ATTACHMENT A

SPECIFIC MODIFICATION REQUESTS

I certify under penalty of law that this October 19, 1995, request to modify the Post Closure Care Permit for The William L Bonnell Company, Inc., to replace certain wells at the facility in order to maintain a groundwater monitoring program consistent with 40CFR264.97. and all attachments were prepared under my direction or supervision in accordance with a system designed to assure that qualified personnel properly gather and evaluate the information submitted. Based on my inquiry of the person or persons who manage the system, or those persons directly responsible for gathering the information, the information submitted is, to the best of my knowledge and belief, true, accurate, and complete. I am aware that there are significant penalties for submitting false information, including the possibility of fine and imprisonment for knowing violations.

Re: Notice of Deficiency
RFI REPORT

FIGURE #1

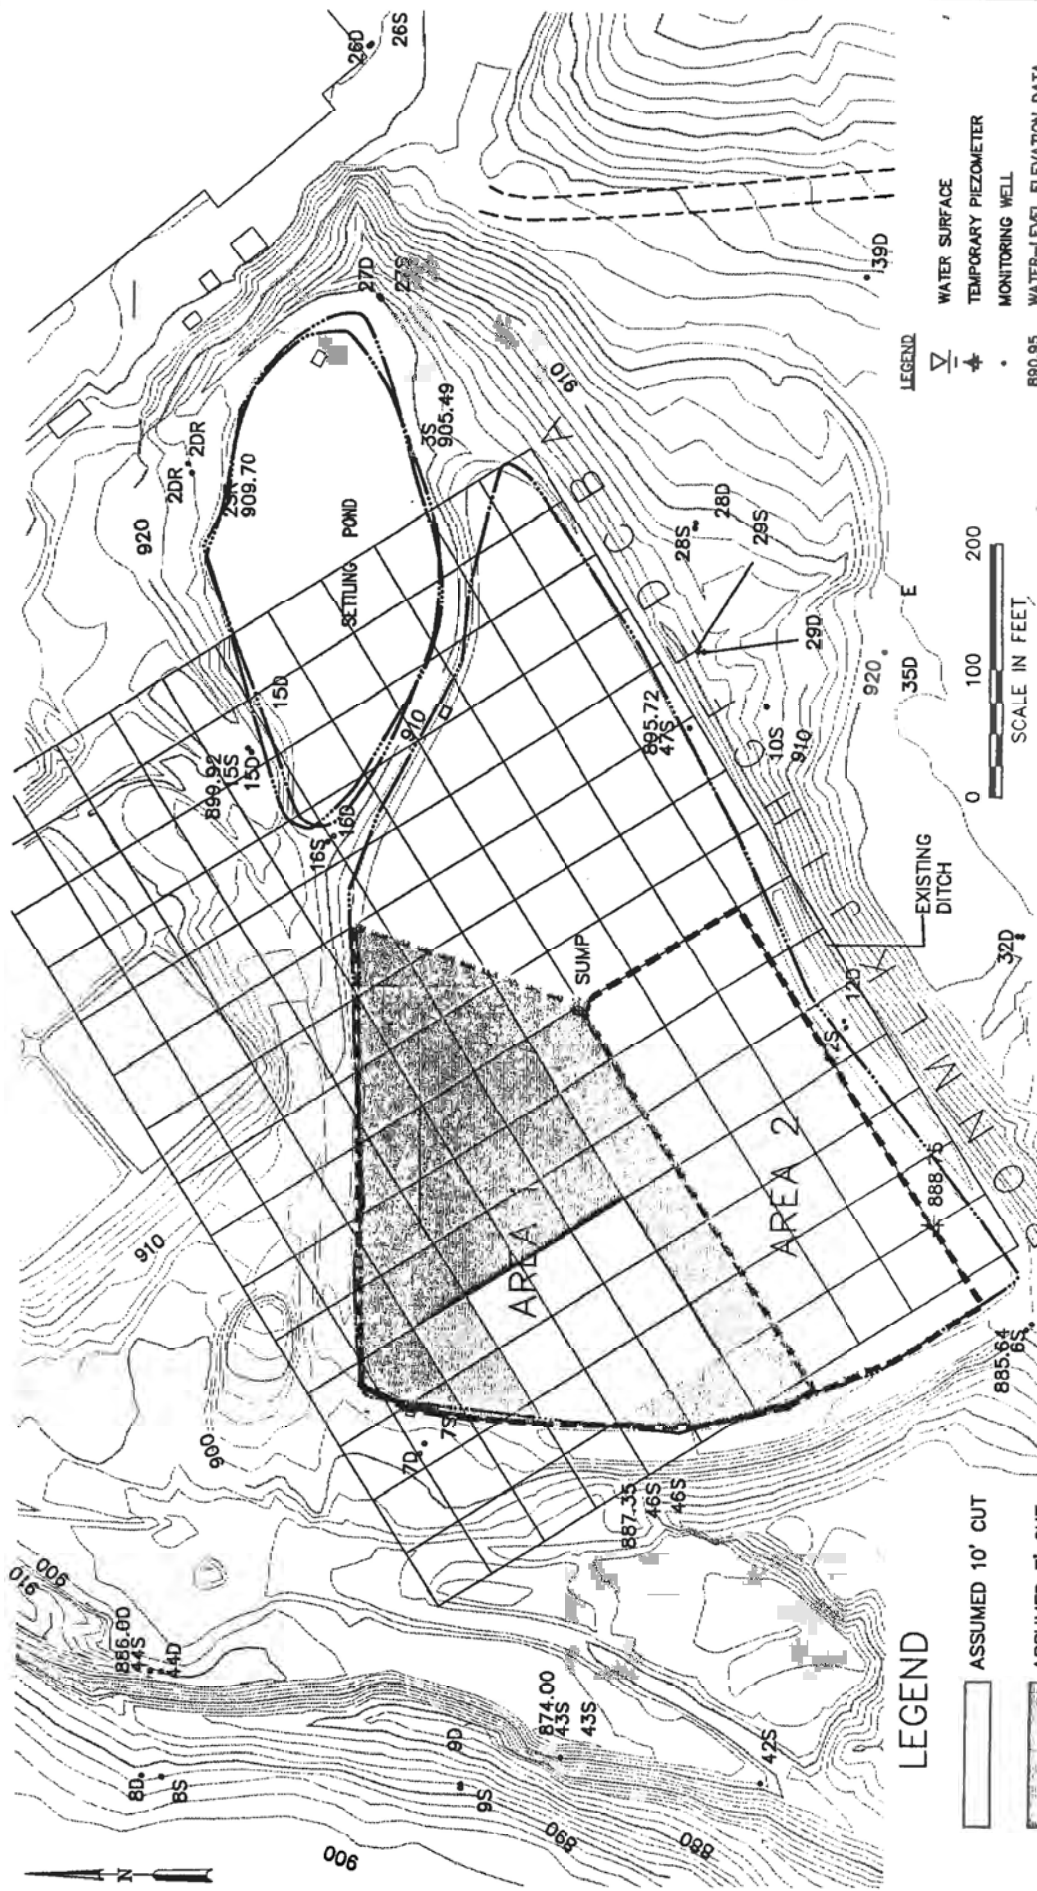
Recent test pits dug in the polishing pond revealed the presence of soils containing oil and grease in the northwest portion of the polishing pond. Affected soils ranged in depth from an estimated 3 to 10 feet over a 2.2-acre area (refer to Figure 1). In light of this discovery, you have asked that EMCON determine the cost-effective manner of completing the closure of the polishing pond.

Based on the estimated horizontal and vertical extents of contaminated soil shown in Figure 1, we estimate 20,100 CY of material would need to be handled under the current program to clean-close the area. Based on conversations with you and Darold Wiggins, we understand that Bonnell's incremental cost of excavating, solidifying and placing soil is \$4.20/CY. Note that this is incremental cost only, and does not include the costs of dewatering, water treatment, decontamination, etc. It also does not address extensive working of the soil to solidify it so that it can be readily compacted in the landfill area. Visual inspection of the soils in question lead us to believe that additional effort will be required to solidify the soils. Darold estimated that this would add an additional \$1.00/CY to the cost. Applying a total unit cost of \$5.20/CY to the estimated 20,100 CY of soil provides an estimated cost of \$104,000 to continue the current method of closure and clean-close the area.

SURFACE IMPOUNDMENT CLOSURE SCHEDULE

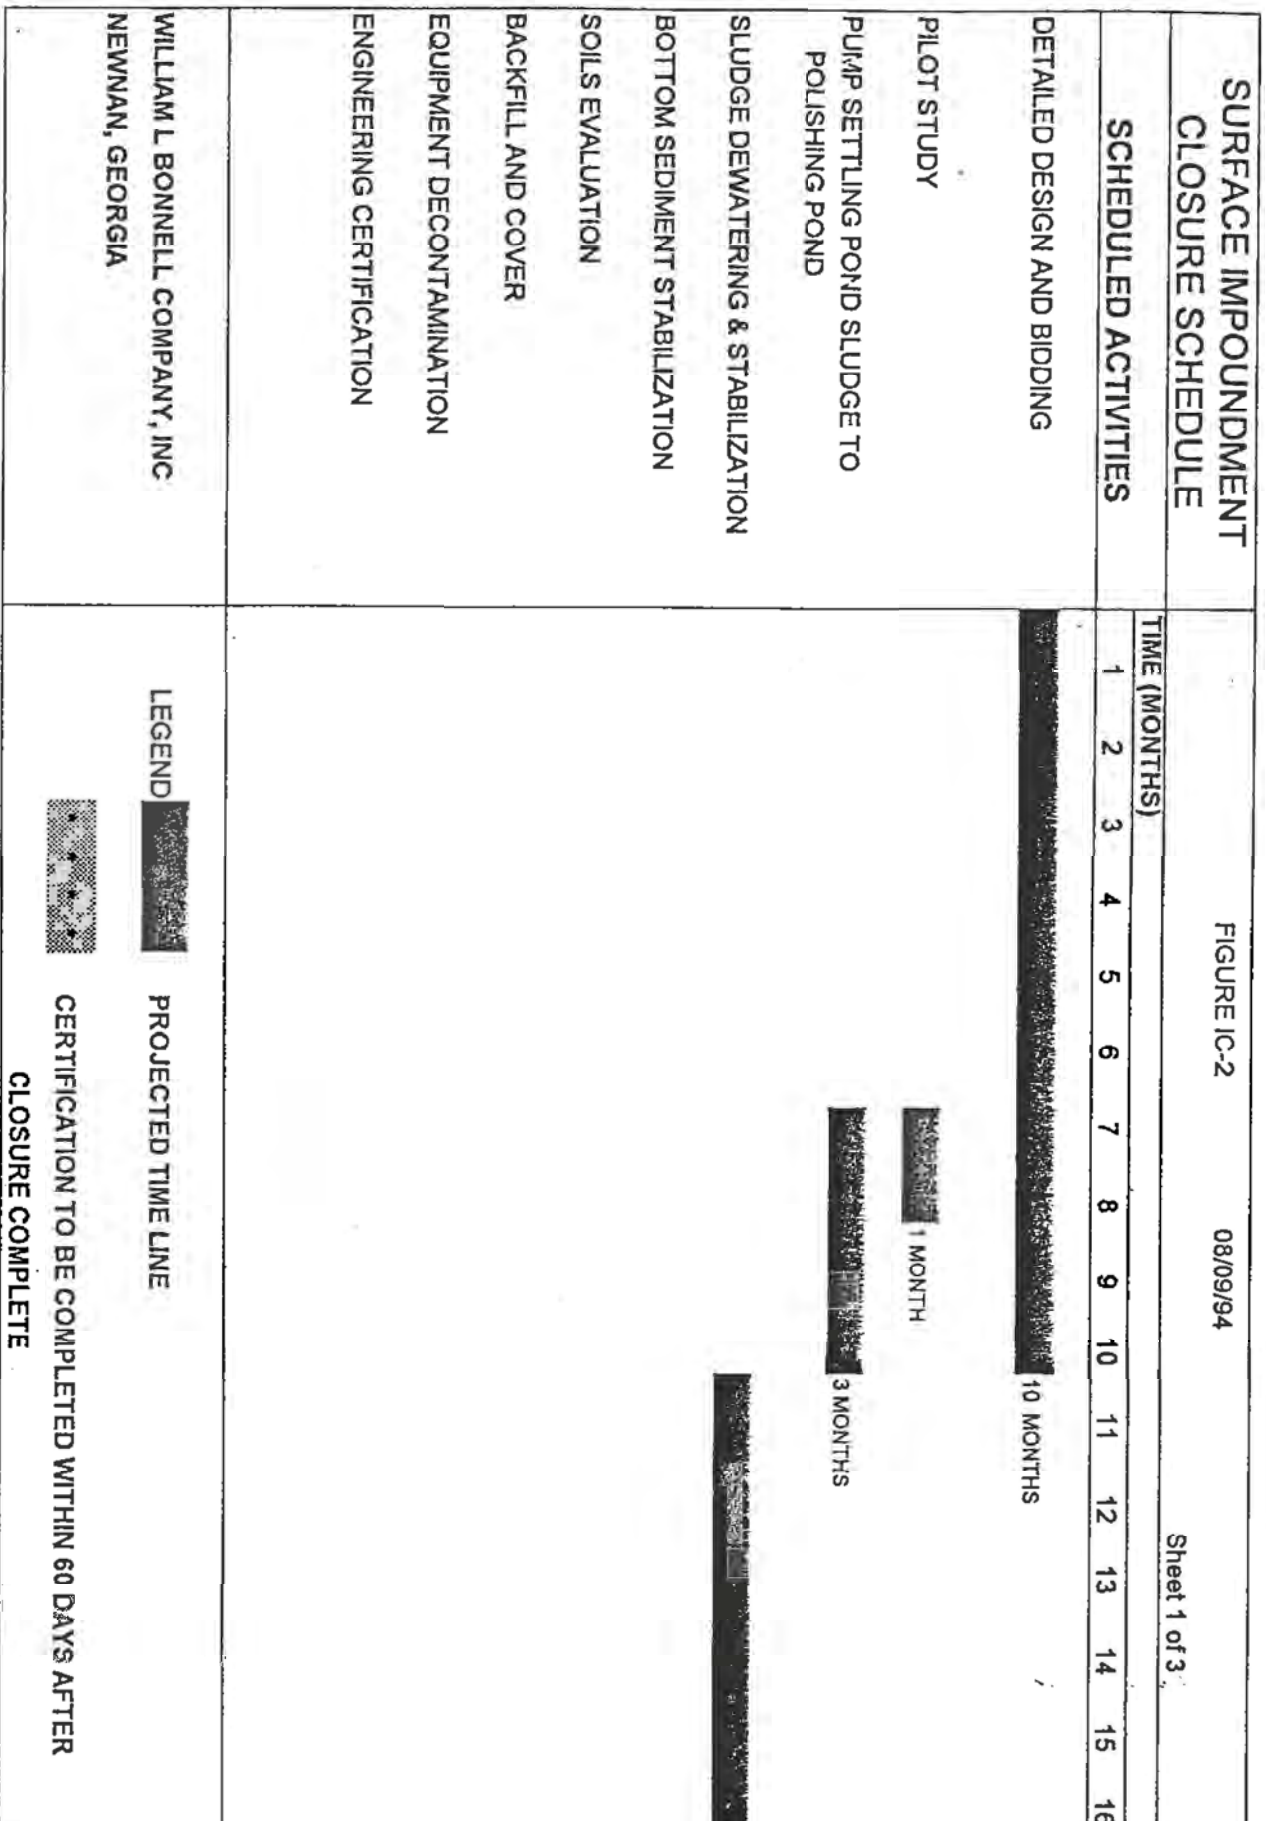
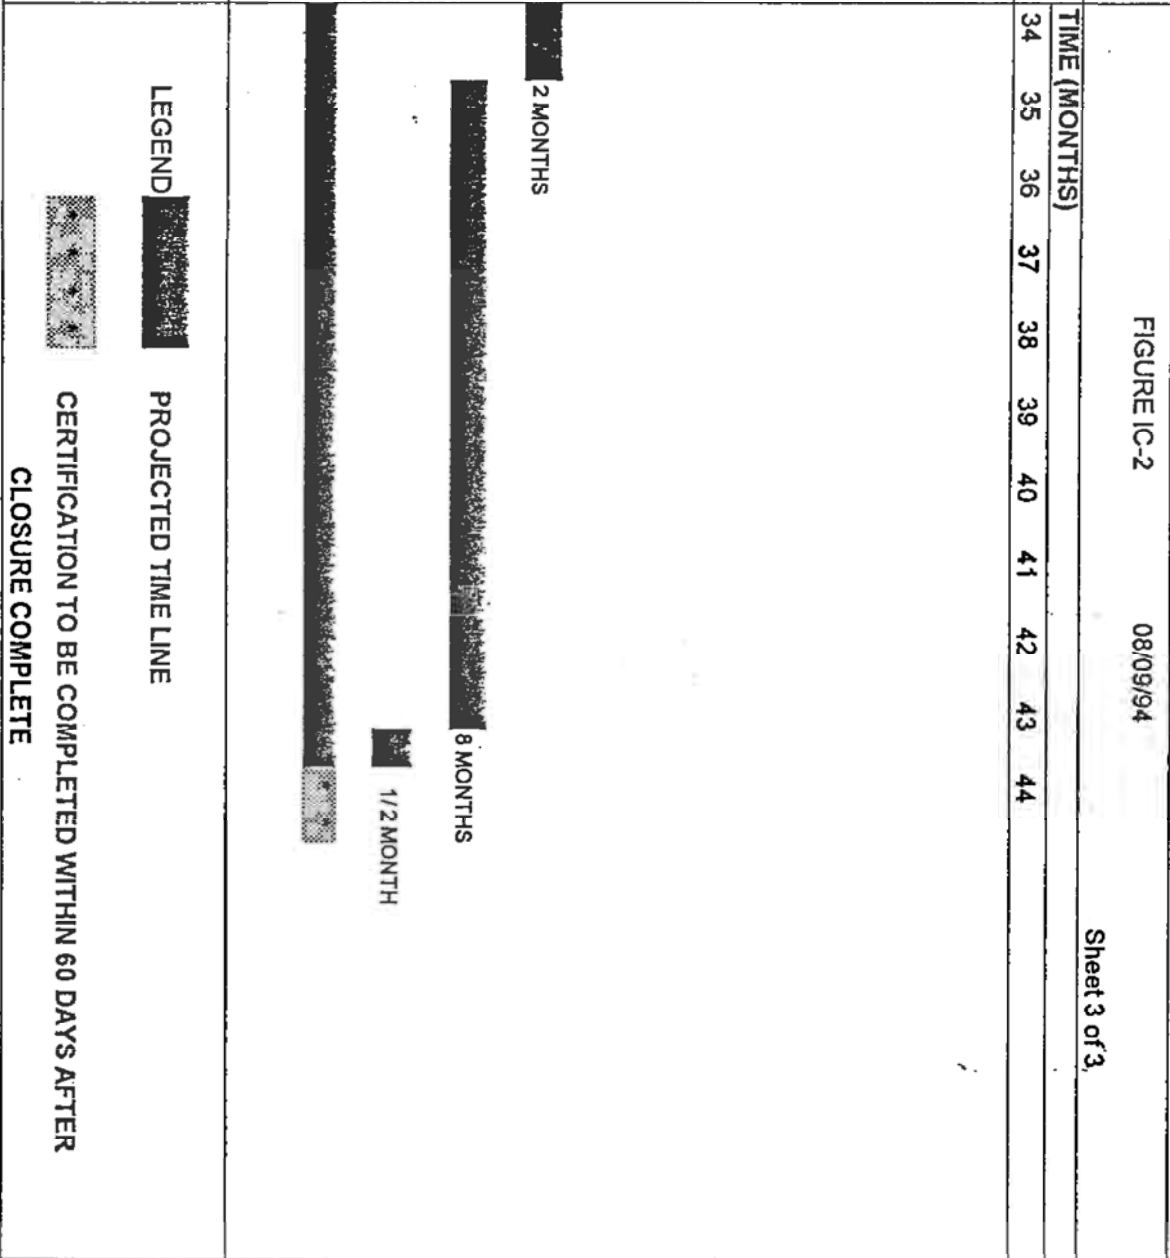
In accordance with 40 CFR 270.42(a), Bonnell requests a Class 1 permit modification. The basis of the request as a Class I modification is contained in D. Closure, 1. b. of Appendix I to 270.42. We have attached a revised Figure IC-2, Impoundment Closure Schedule, from our Part B Post-Closure Care Permit Application.

The schedule presented as Figure IC-2 should be deleted and the attached schedule should be included in the revision to Section IC as Figure IC-2.
